Docket Item # 3
BAR CASE # 2009-0016

BAR Meeting
July 8, 2009

ISSUE: Alterations
APPLICANT: Patrick Camus for Ken and Esther Carpi
LOCATION: 117 South Lee Street
ZONE: RM/Residential

The applicant is requesting approval of a Certificate of Appropriateness for alterations to the stoop at 117 South Lee Street. The Board has already approved a Permit to Demolish/Encapsulate, a Waiver of the Rooftop HVAC Screening Requirement, and a Certificate of Appropriateness for an addition and alterations except for a new stoop design.

Figure 1. Site plan with approved addition and alterations (Note: revised stoop projects four feet from building face but will encroach three feet into the public right-of-way).

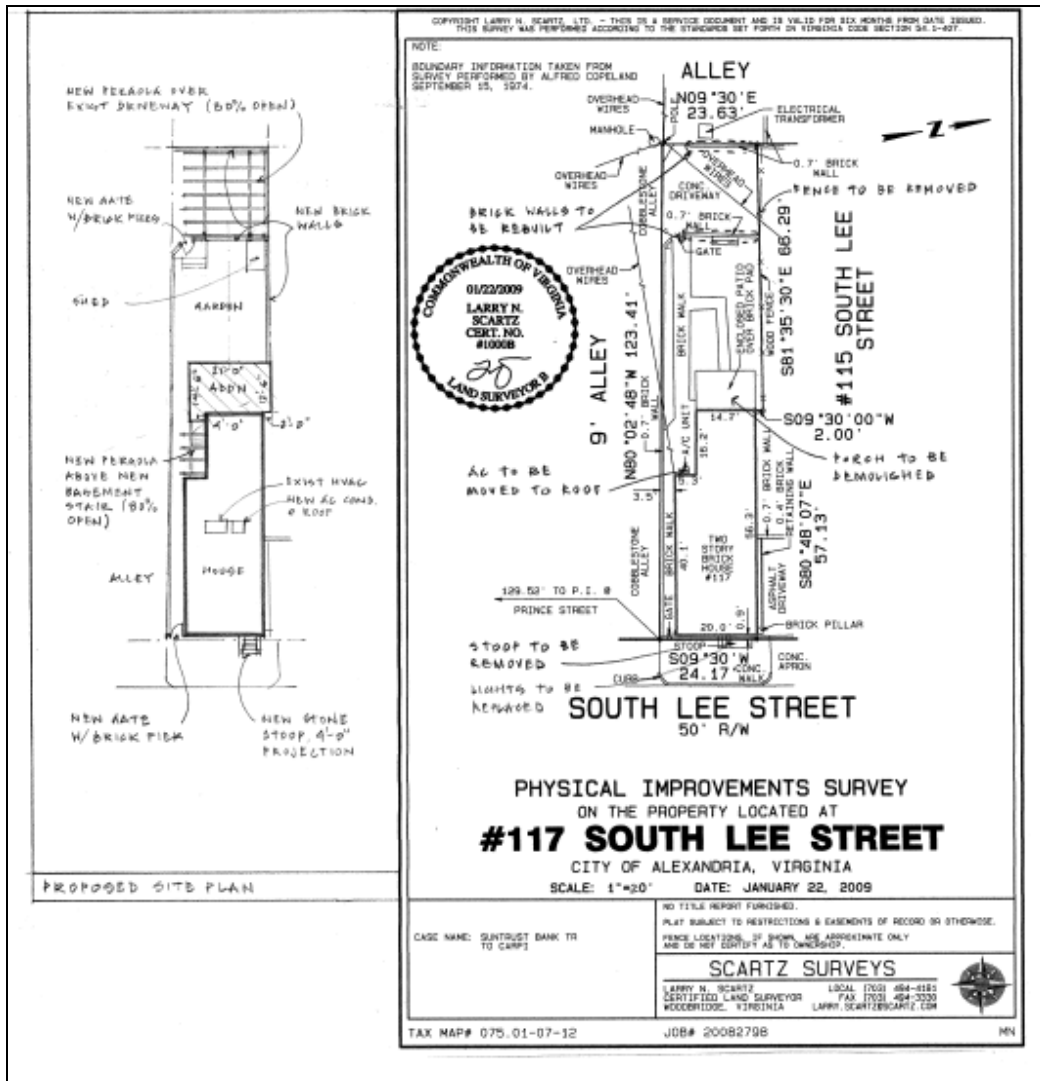
The proposed stoop complies with Zoning Ordinance regulations. Due to the width of the public right-of-way on South Lee Street, according to the City Code, a stoop may encroach 3 feet at this location.

Figure 6. Proposed revised front stoop, plan and elevation.

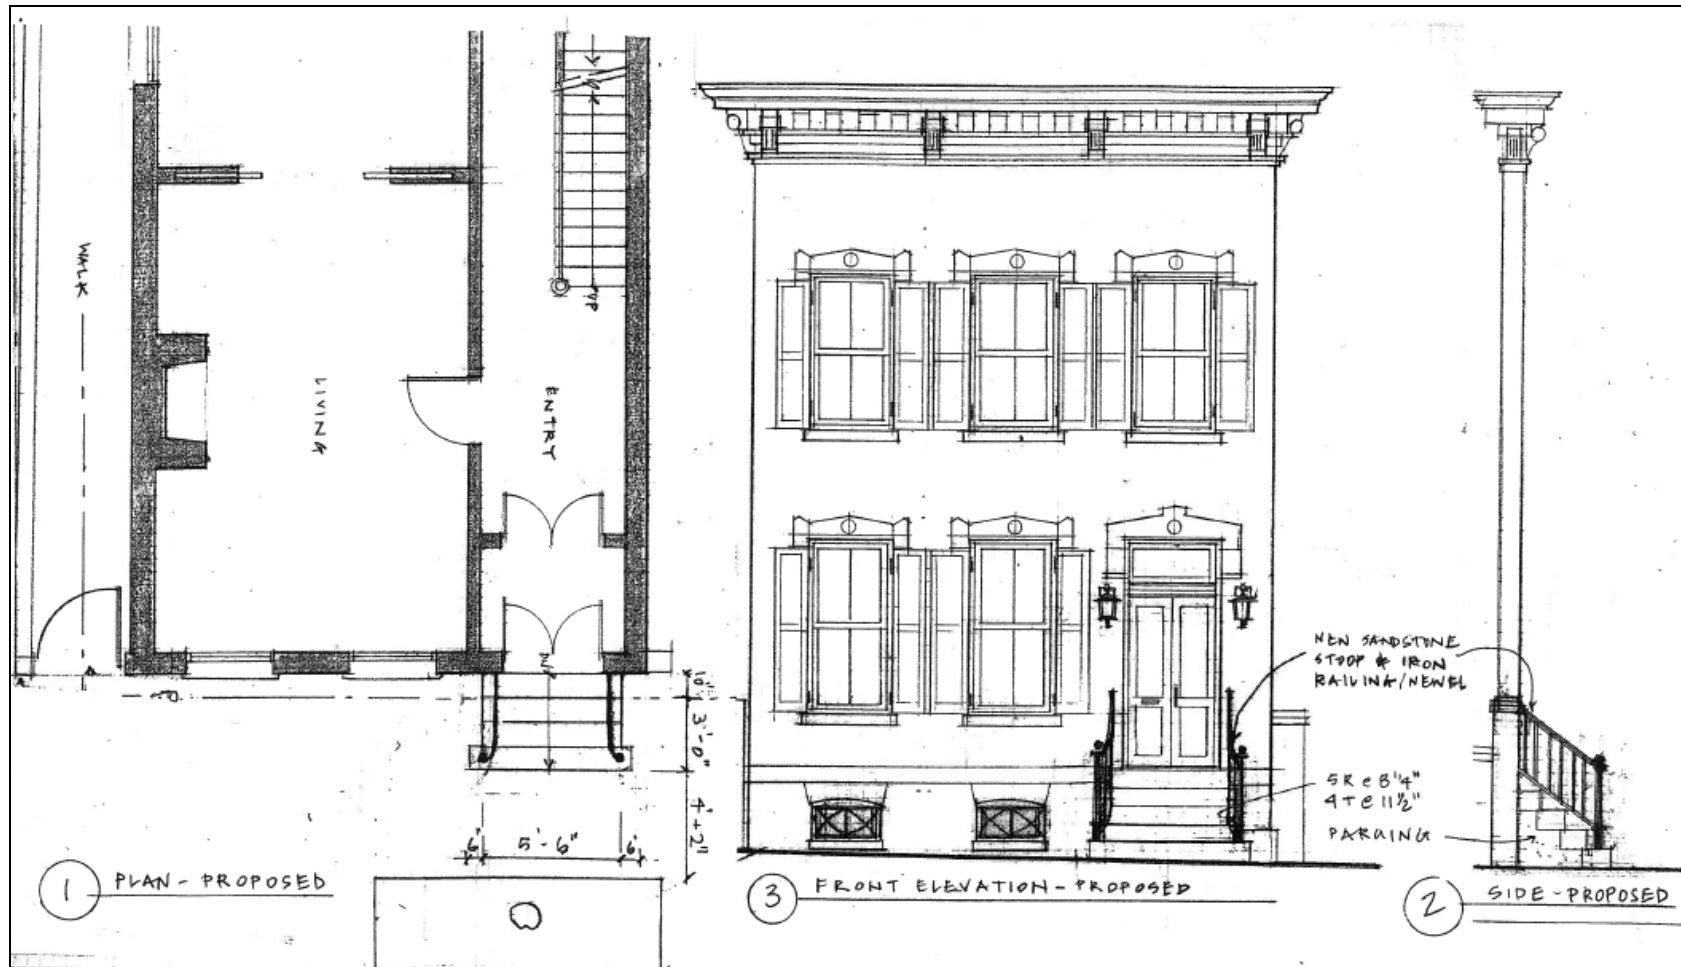
The applicant is proposing to remove the existing side-oriented front stoop. The proposed stoop will project 4 feet from the face of the building and will encroach 3 feet into the public right-of-way. The revised stoop will be sandstone instead of limestone which was proposed in earlier submissions. The applicant has simplified the proposed stoop by reducing the width of the treads: 5.5 feet instead of 7.25 feet. The applicant has added a newel at the base of the iron railing, curving outward at the bottom tread.

The existing side-loading front stoop, made of brick and concrete, does not appear to be historic. The revised stoop is consistent with the *Design Guidelines* which state that “stoops, steps and railings should be made of materials which are sympathetic to the building materials generally found in the historic districts” and “should be appropriate and compatible with the historic architecture of the building.” Staff found the proposed limestone stoop in the previous submissions to be appropriate; however the Board found that the stoop design should be further studied. The revised design has been simplified and includes elements typical of Victorian stoops, such as the use of sandstone and a pronounced railing with newel posts. The reduction in the width of the treads and encroachment onto the sidewalk further simplifies the design and makes the stoop more appropriately scaled to the building. The revised design is appropriate and consistent with the *Design Guidelines*.

STAFF RECOMMENDATION: Staff recommends approval of the revised stoop as submitted.

IV. STAFF RECOMMENDATION: Staff recommends approval of the application as submitted.
